Alabama State Port Authority
Addendum to R&P or Specification Booklet

Project Name Terminal Railway Office Addition/Renovation

Project No. 11012 **Task No.** 02 **Addendum No.** 2

| JOB NO. 4146-22 | CHECKED BY JDG | DATE 05/31/22 | DRAWING NUMBER 4146-S4A | |

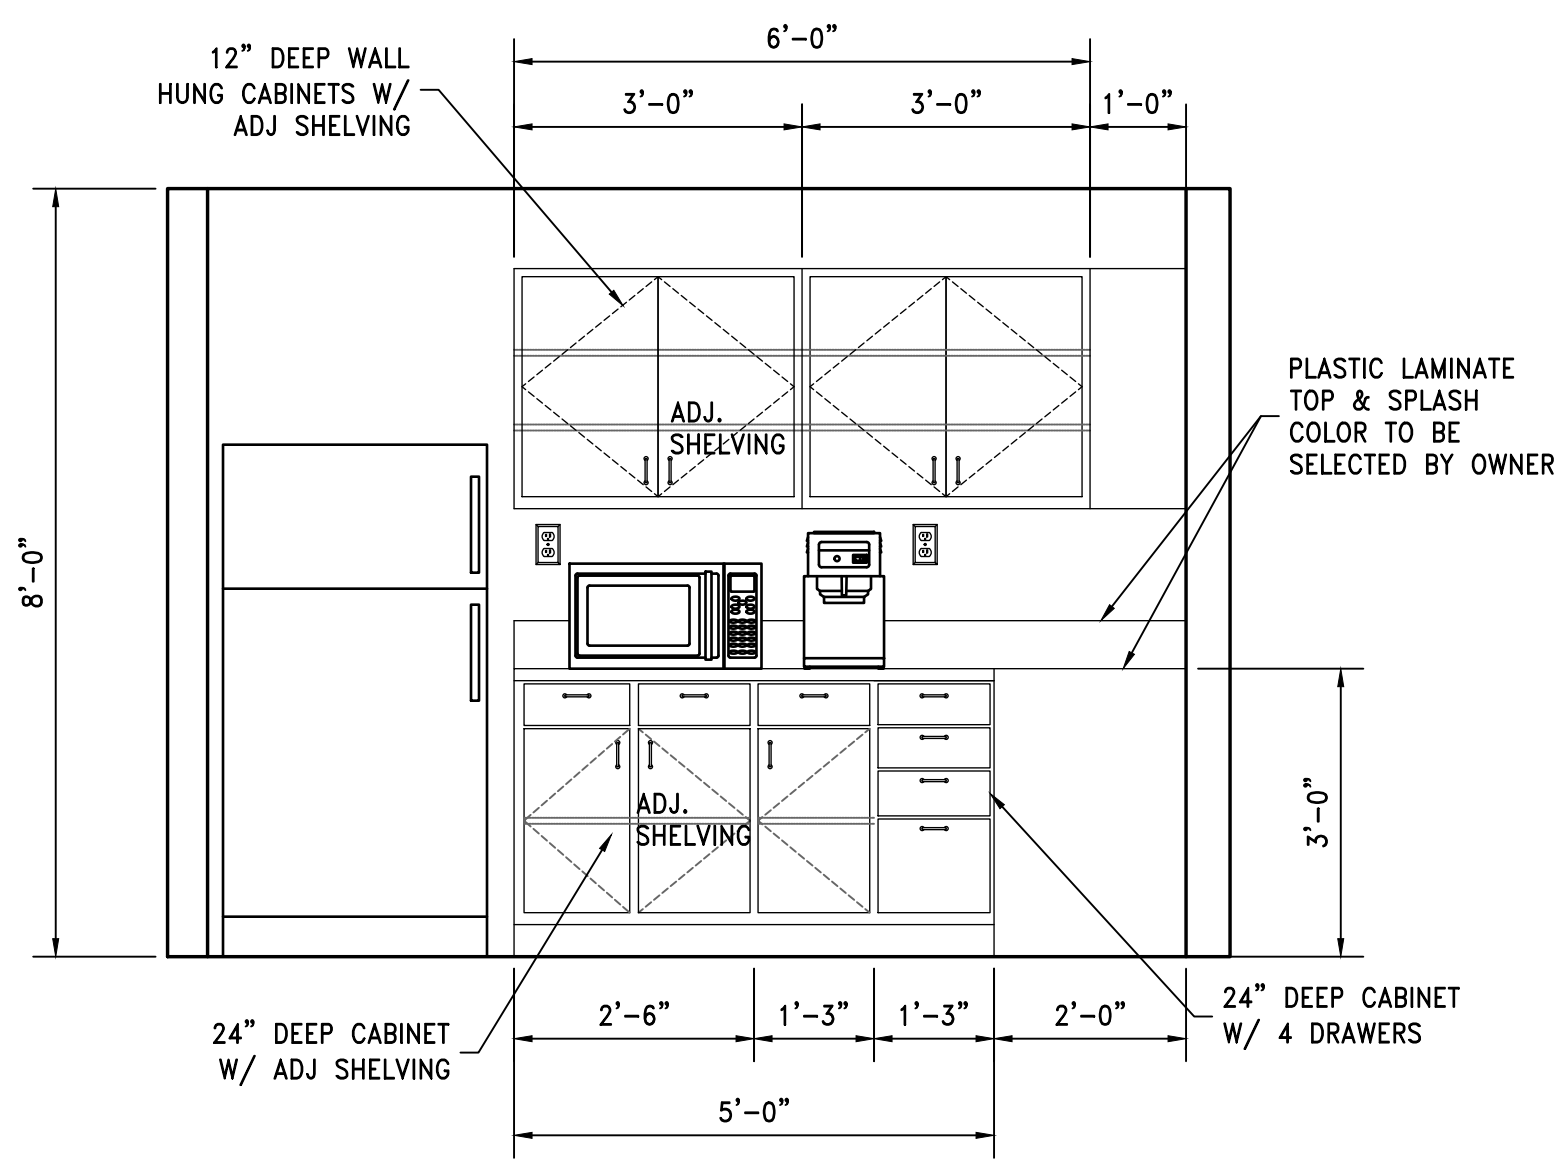
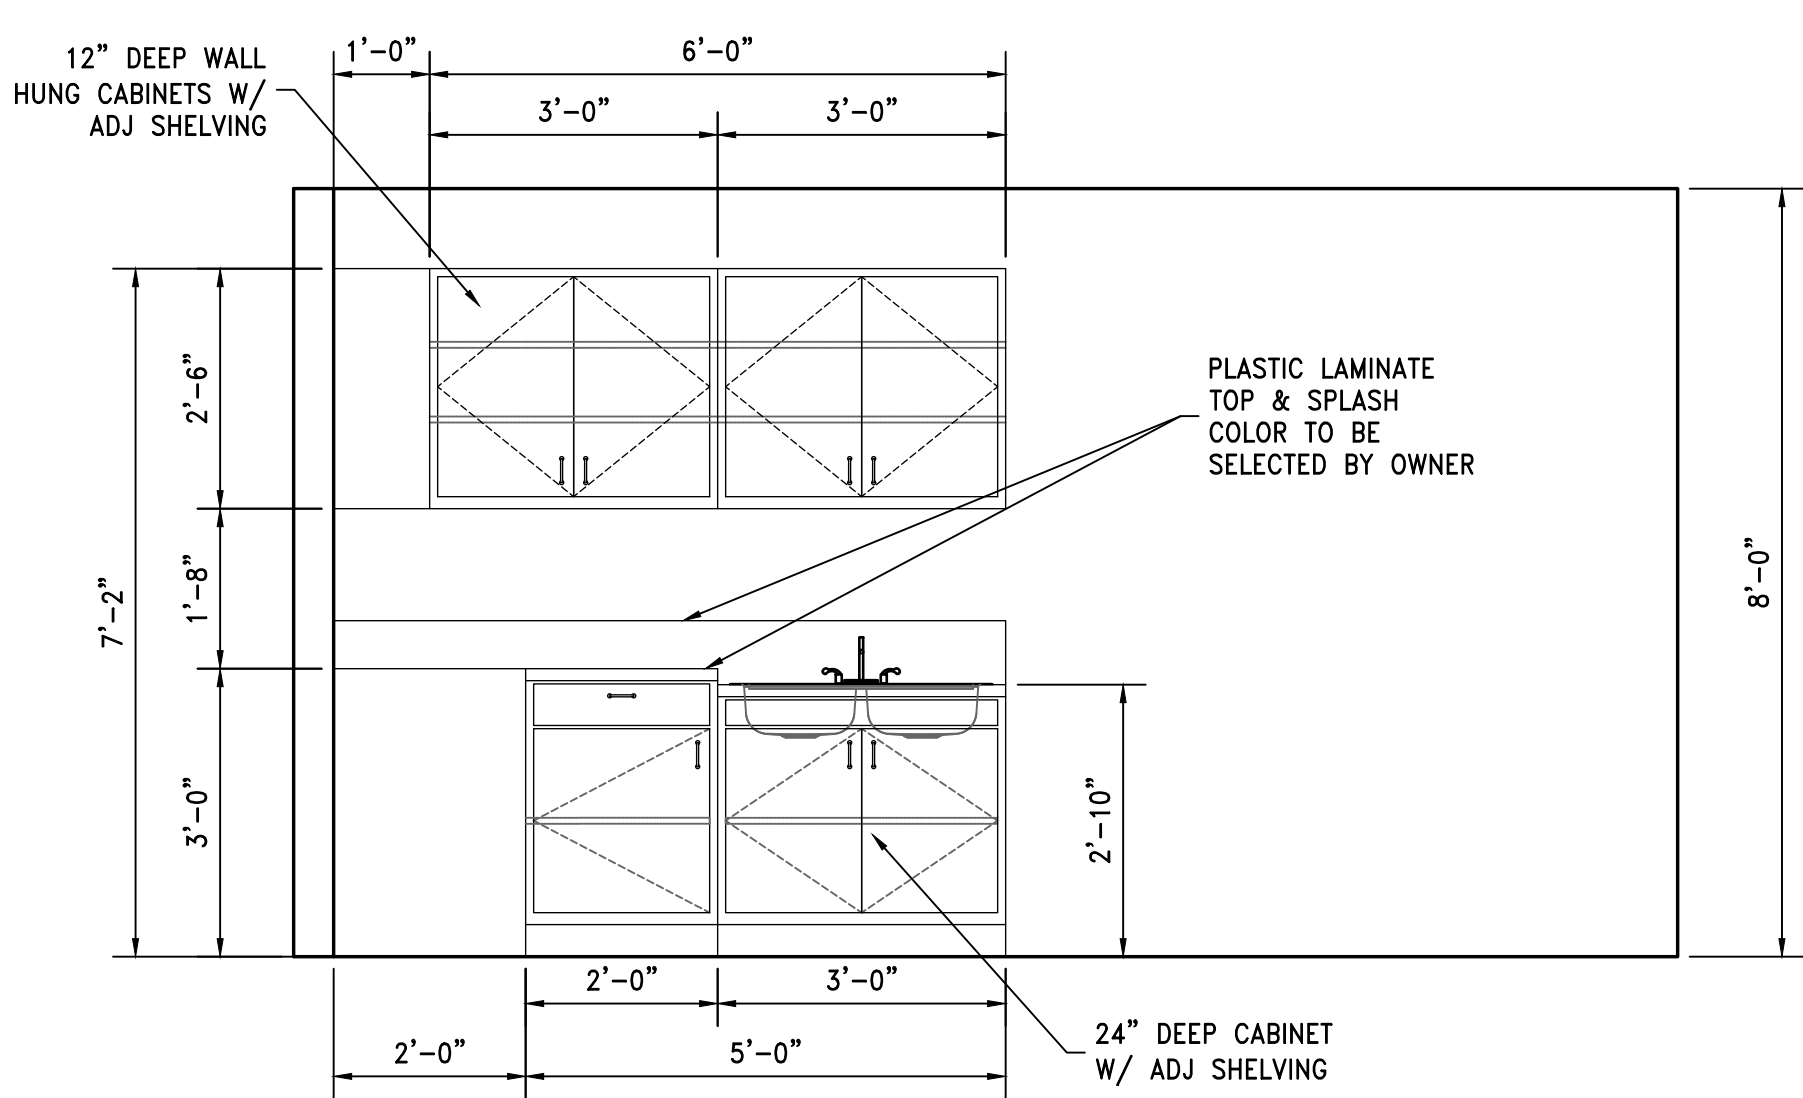
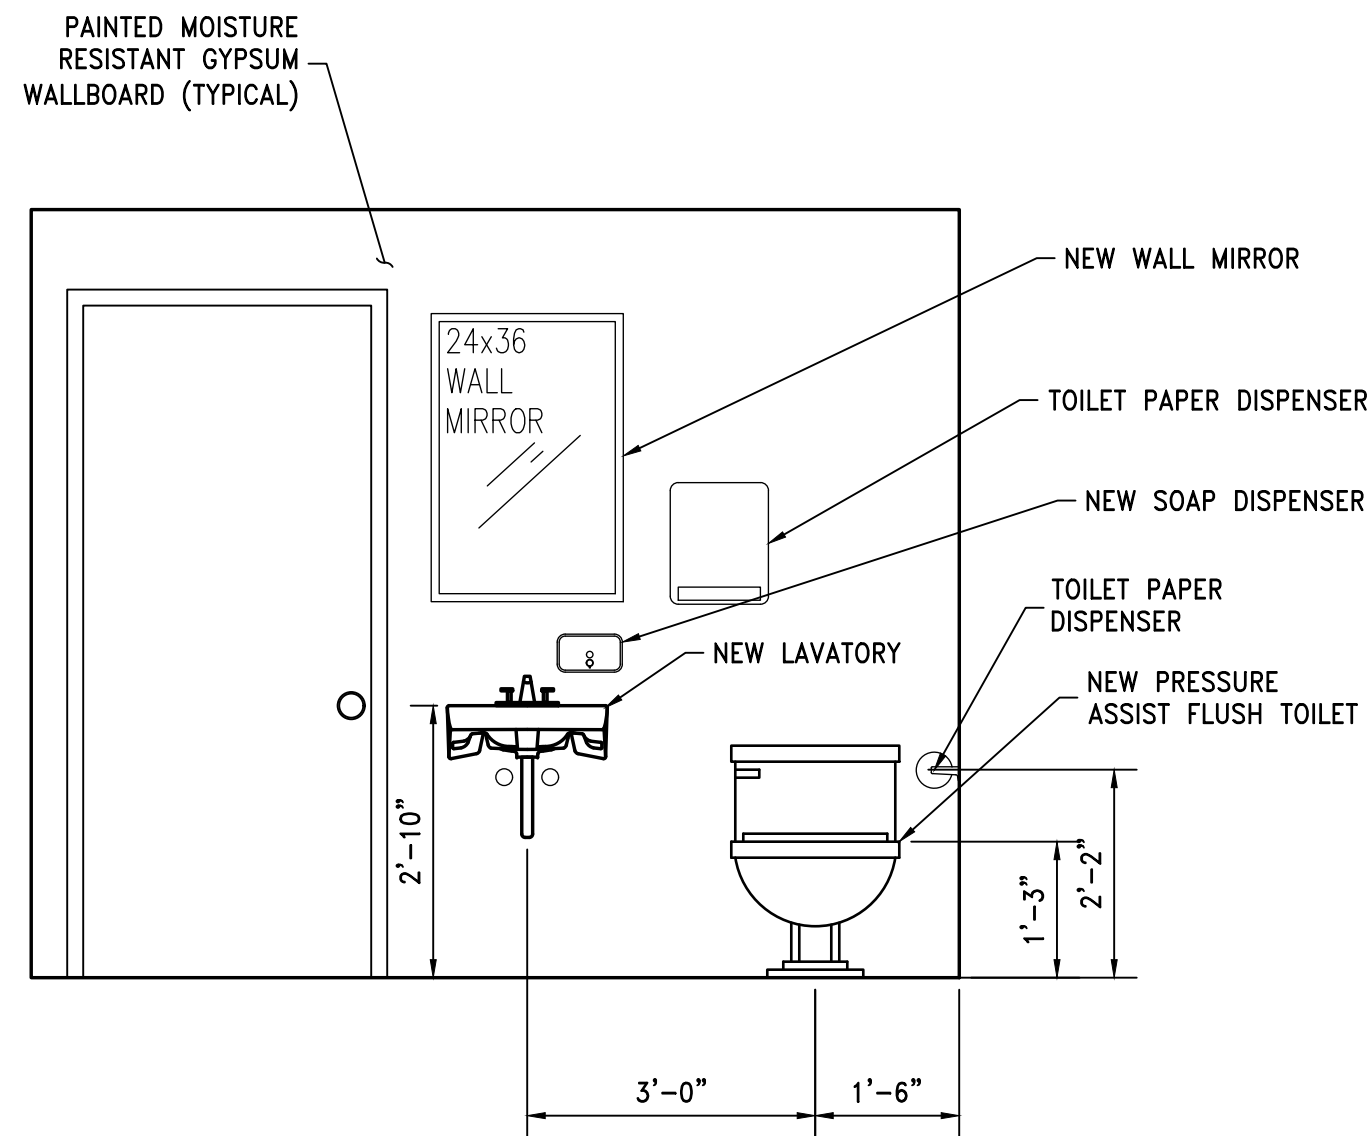
| Item | Description |
|------|---|
| 9. | Question: According the bid documents the breakroom is illustrated with case work. Please provide details and specs for this scope. Answer: A new drawing (4146-S4A) has been created to provide details and specifications for the case |

| | <p>work in breakroom 209.</p> <p>DWG. 4146-S4A Rev C is attached and is hereby incorporated into the bid documents by this addendum.</p> |

| JOB NO. 4146-22 | CHECKED BY JJM | DATE 07/01/22 | DRAWING NUMBER 4146-E1 | |

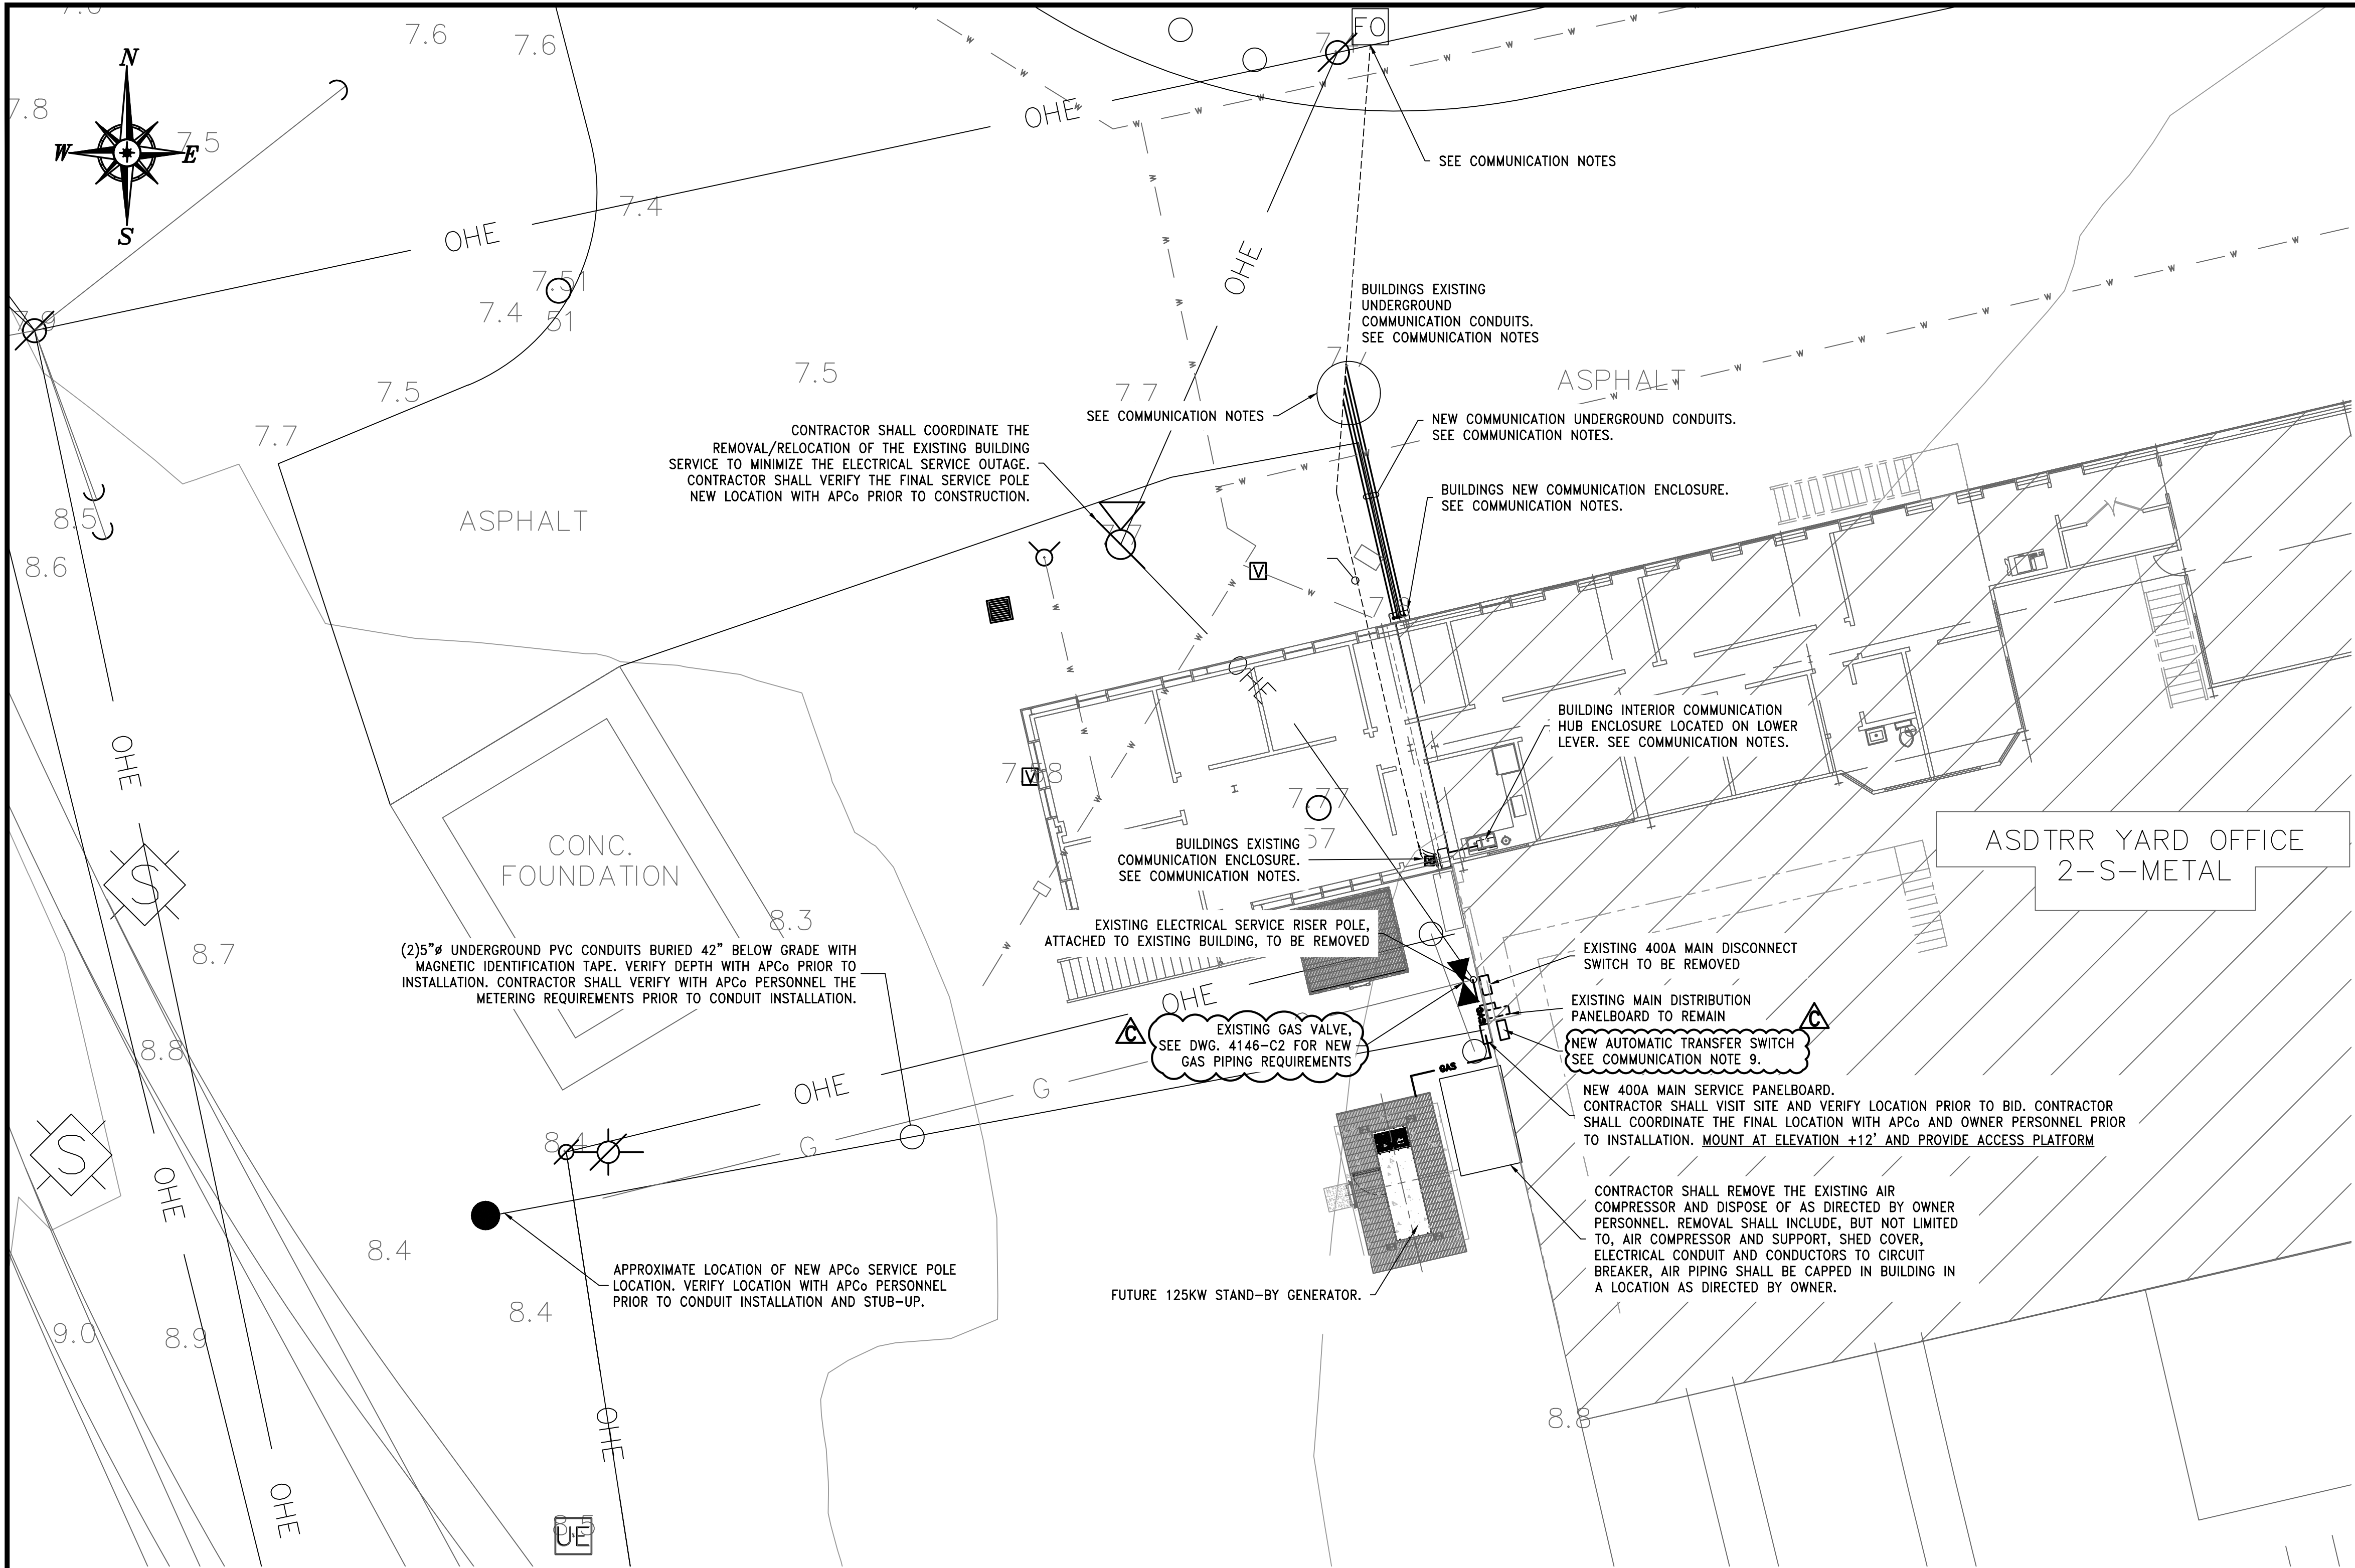
| Item | Description |
|------|---|
| 5. | Note 9 on DWG.4146-E1 has been revised to clarify the contractors requirement for installation of the automatic transfer switch. DWG. 4146-E1 Rev C is attached and is hereby incorporated into the bid documents by this addendum. |

9. CONTRACTOR SHALL FURNISH AND INSTALL NEW KOHLER #KSS-AMTA-260-S (OR APPROVED EQUAL) AUTOMATIC TRANSFER SWITCH WITH GENERATOR MONITORING SYSTEM FOR FUTURE 125kW STAND-BY GENERATOR INSTALLATION. 125kW STAND-BY GENERATOR SHALL BE A FUTURE ADDITION BY OTHERS. CONTRACTOR SHALL LOCATE THE ATS IN A LOCATION +1' ABOVE THE FEMA FLOOD ELEVATION AE, EL.+11. BOTTOM OF ATS SHALL BE AT ELEVATION +12'. ATS SHALL BE INSTALLED INDOORS AND SURFACE MOUNT. VERIFY LOCATION WITH ASPA PERSONNEL PRIOR TO INSTALLATION.

| TITLE | | | | |
|---------------------------------|------------|----------|----------------|------------|
| 4146-22 | JJM | 07/01/22 | 4146-E2 | |

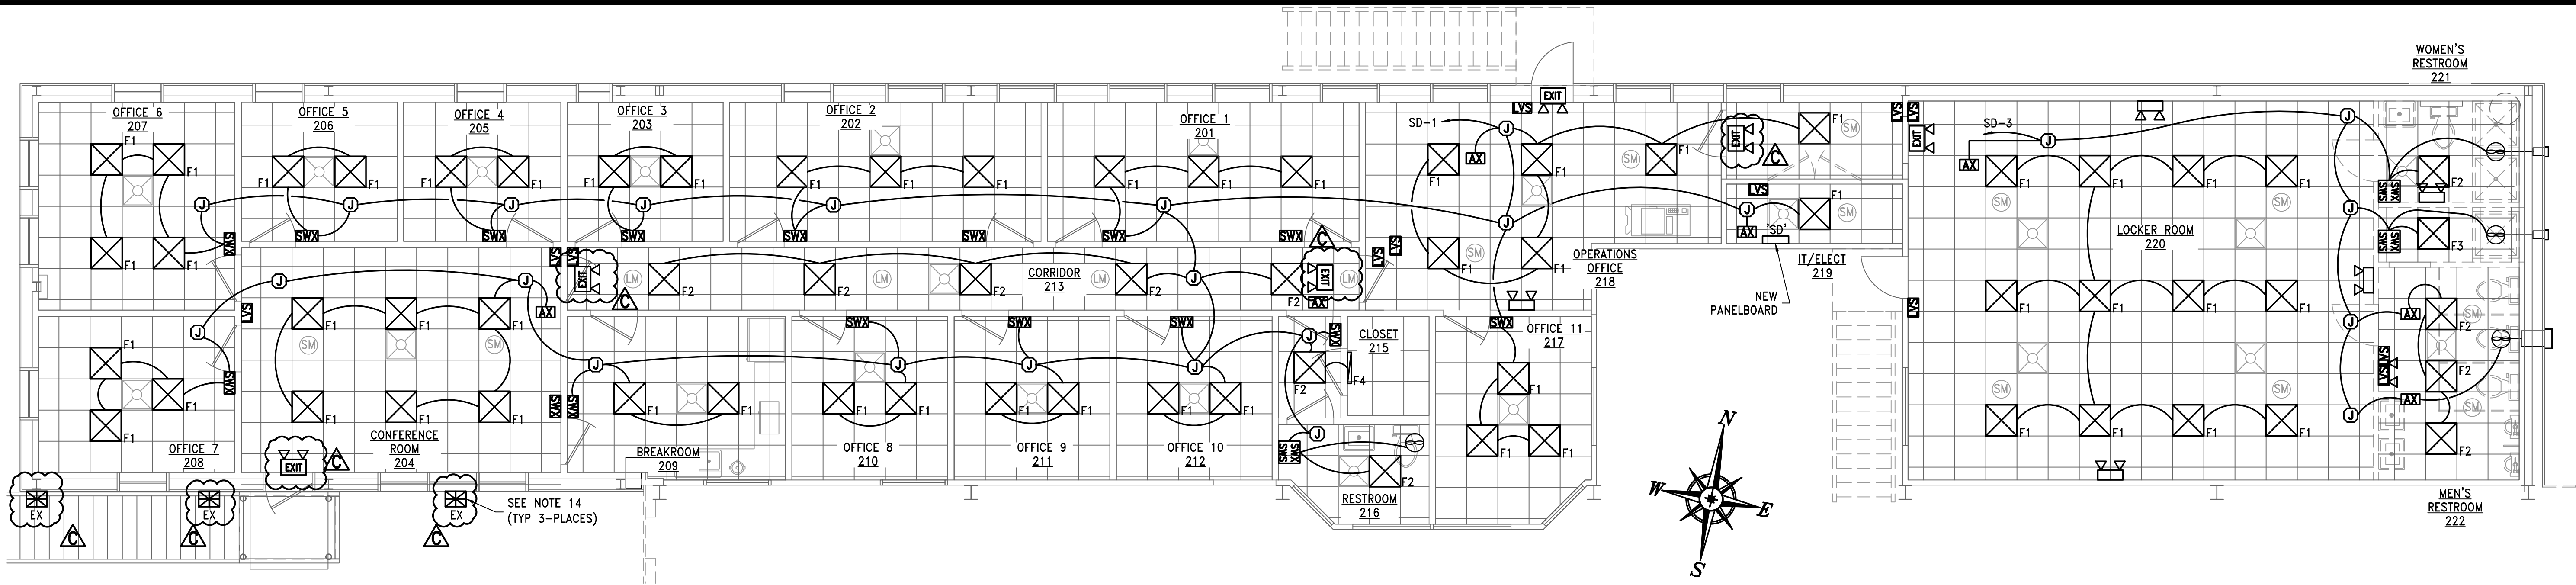
| Item | Description |
|------|---|
| 6. | Additional exit fixtures and exterior wall mounted area fixtures have been added to DWG. 4146-E2. DWG. 4146-E2. Rev C is attached and is hereby incorporated into the bid documents by this addendum |

- SEE REFERENCE DRAWING 4146-E3 FOR OFFICE LIGHTING CONTROL PLAN.
 - CONTRACTOR SHALL ROUTE 1/2" CONDUIT W/(2)#12AWG & (1)#12AWG GRD FROM THE EMERGENCY LIGHTING ELECTRICAL TO EACH EXTERIOR EGRESS LIGHT FIXTURE 'EX'. EXTERIOR LIGHT FIXTURES 'EX' SHALL BE CONNECT TO CONSTANT POWER FROM THE LIGHTING CIRCUIT SERVING ROOM 204.
